SUBMISSION re ARMOUR ENERGY
Application to vary Environmental Authority
EPPG00342913 (to supplement earlier
submission)

Prepared by Leanne Brummell
30 Victoria Street ST GEORGE QLD 4487
Contact details – leannebrummell@ourfishingshack.com
Mobile 0455344862

05/11/2018

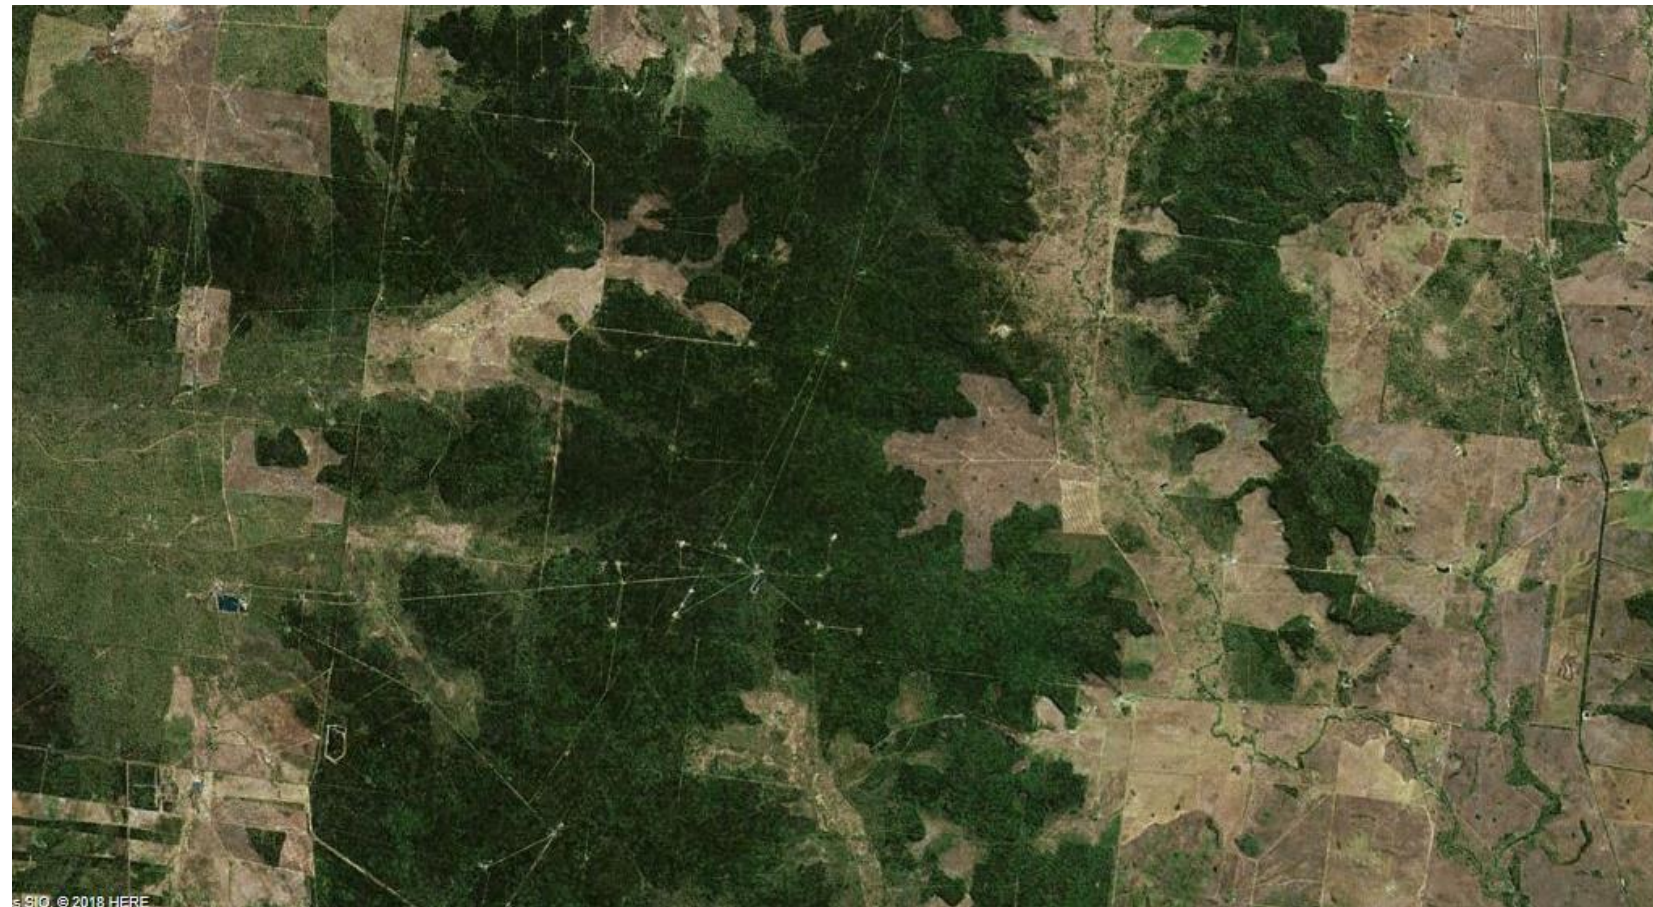
Google maps clearly shows where the water runs. As mentioned in the first part of my submission, the creeks in the area will be impacted by floods.

PL511 - Where Armour Energy has constructed and fracked a well named Myall Creek 4A and announced on 1 November they have spudded well Myall Creek 5A. This approval also states Maranoa Council to supply water. It's a drought, how do they get water if no one else can?

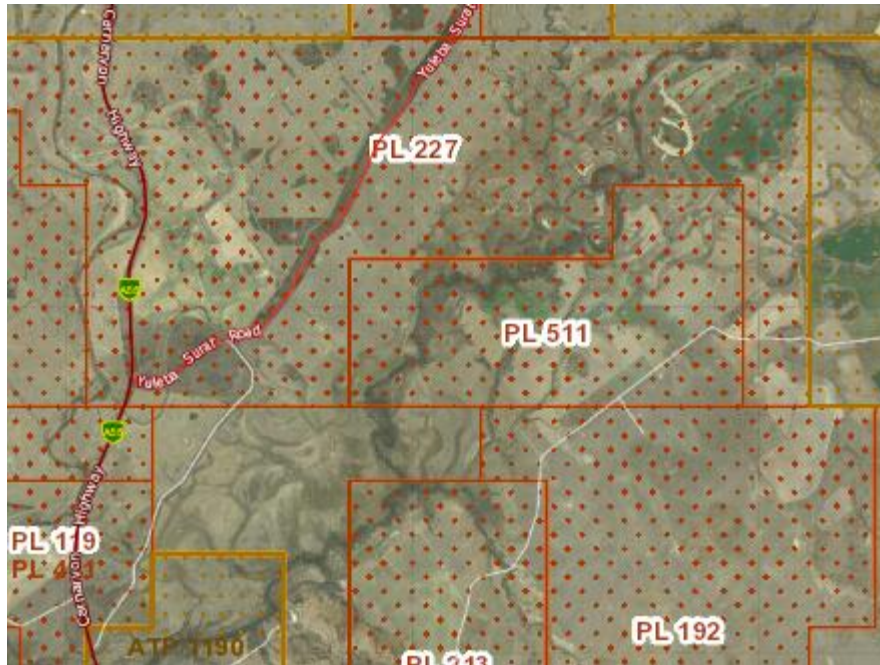
Locals would have opposed fracking here if they had known about the application.

You can clearly see where the water runs.

Figure 3-3 Major geological structures in the Surat CMA

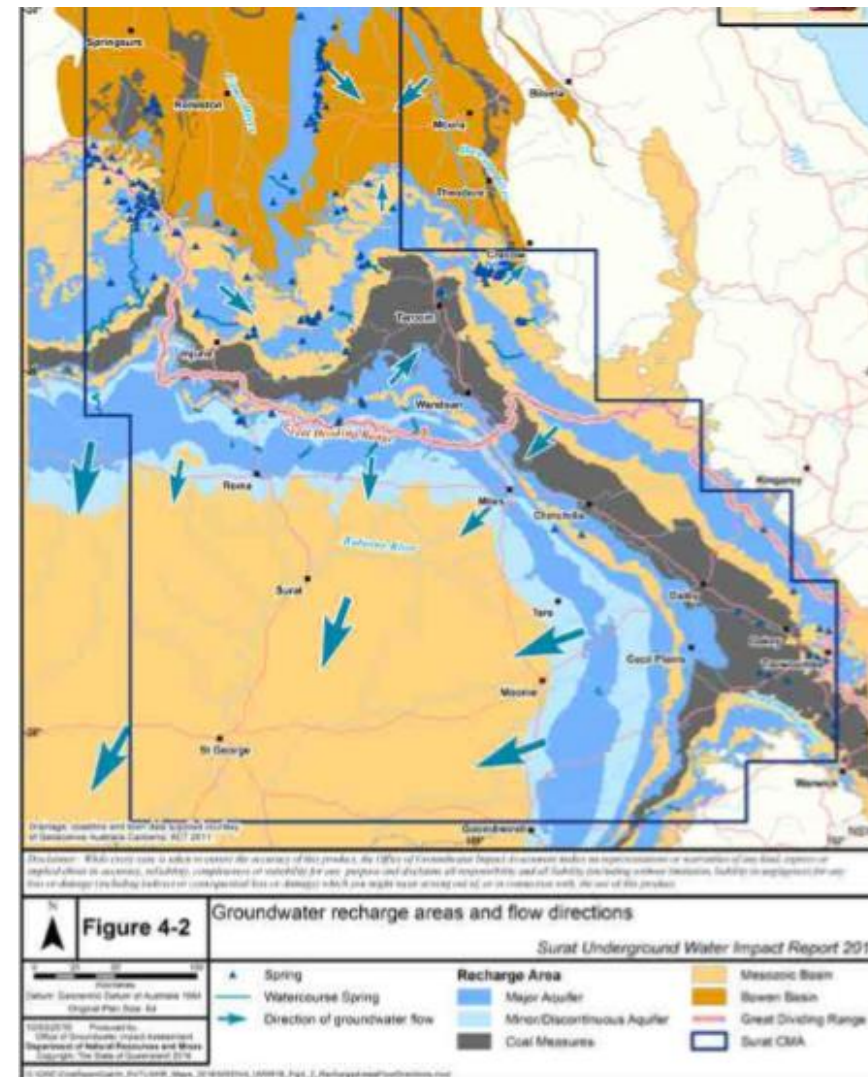
Underground water from PL71 flows to the Balonne Shire. This has not been considered in the application.

What is the impact to the towns in the Balonne Shire if something does go wrong and there is a major disruption to the Great Artesian Basin? How do these towns that rely 100% on Artesian water get water? Does Armour Energy 'make good'? How? It's not in the application.

Remember too the Surat Cumulative Water Impact Report is only based on models. Models are never accurate, they are only models.
